2AM-MEL1631 Water Licence Amendment

Technical Comment Responses

Submitted to:
Nunavut Water Board

November 13, 2020

Figure 1. Monitored and Forecasted TDS Concentration in CP1

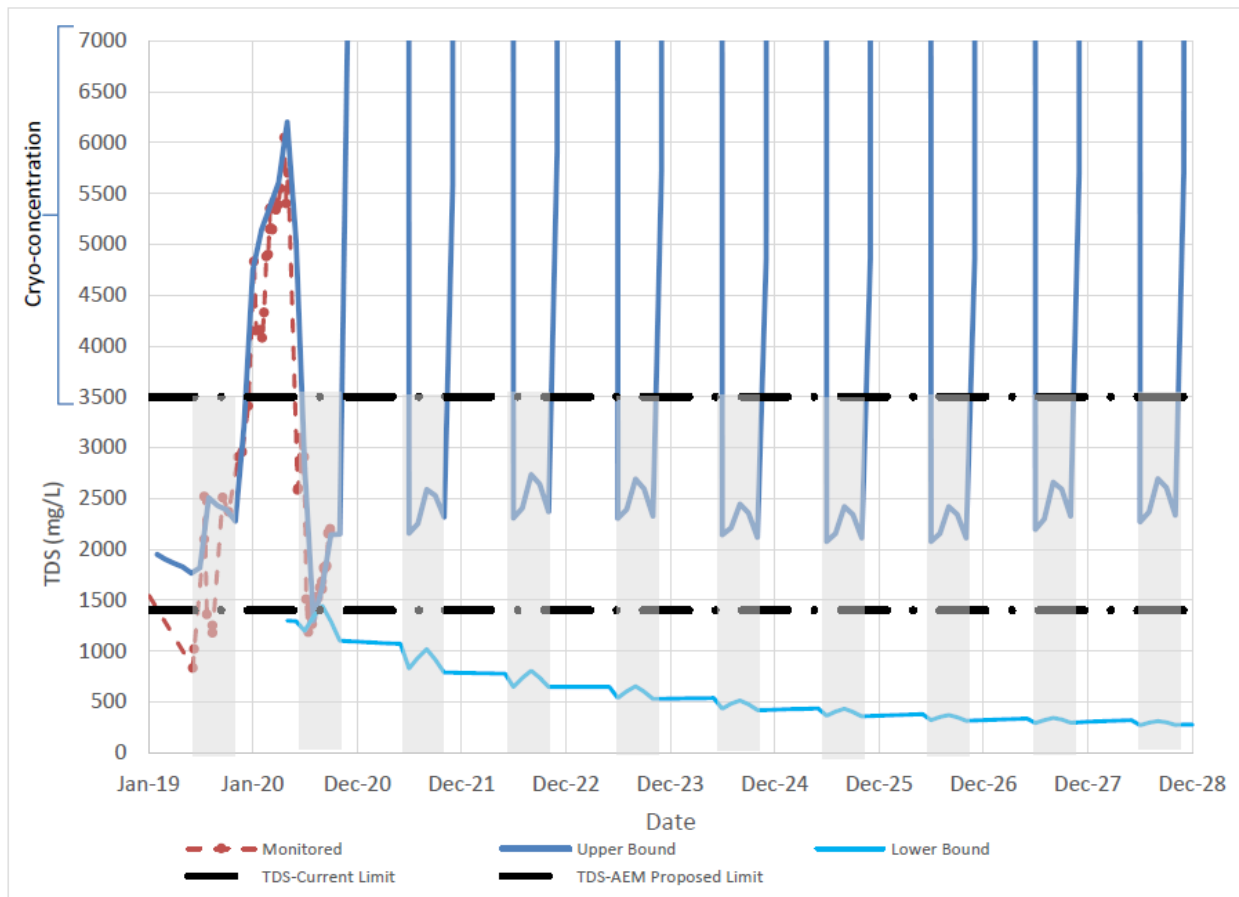
To add confidence in the inputs values provided for the water quality model in terms of concentrations for the main camp STP effluent, WRSF runoff loading, ore stockpile runoff loadings and loadings from the tailings storage facility runoff facility, we recommend that Agnico Eagle provide the range in values and justification for the use of the average instead of a more conservative value as well as justification for the use of the 25% reduction in TDS concentrations from Channel 1. We further recommend how model outputs would be impacted if a more conservative 75th percentile values were used as inputs into the water quality model with a particular focus on impacts to Meliadine Lake.

Agnico Eagle requested an increase to the TDS discharge criteria (from 1,400 mg/L to 3,500 mg/L, maximum average concentration) because TDS concentrations in CP1 have been trending upward and have exceeded the regulated discharge limit of 1,400 mg/L.

The August 2020 submission for the Type A Water Licence Amendment included an updated Site Water Balance and Water Quality Model forecast (Appendix A with the submission). This model used less conservative assumptions including: average monthly concentrations, dry year runoff volumes, not accounting for ice formation (and thus cryo-concentration in CP1), potential lags in releases, a year over year reduction in source terms by 25%, and assigning undisturbed land cover types (with associated source terms) within the mine footprint area. Based on this, results from the August model are considered to represent a lower bound set of predictions.

Since submission of the original application and based on comments received during the information request process, Agnico Eagle has taken the opportunity to re-evaluate various inputs to the model including assumptions, source water quality, processes, site conditions, and monitoring data (including data from 2019 and 2020). Precipitation and runoff was higher in 2019 as compared to 2020, so inclusion of data from both years introduced an observed range in natural environmental variability. A high-level mass balance for CP1, with these new inputs, was completed (Figure 1; Attachment WL-TC-3). Results from this model are considered to represent an upper bound set of predictions for the Life of Mine.

The lower bound and the upper bound set of predictions are expected to represent the range of conditions that could occur at the site. The models will be updated annually with the most recent data and will be used to guide daily operations at the site.

Although TDS concentrations in the discharge are expected to be less than 3,500 mg/L during most times of the year, the proposed limit of 3,500 mg/L provides operational flexibility and avoids circumstances that would require future emergency amendment applications.
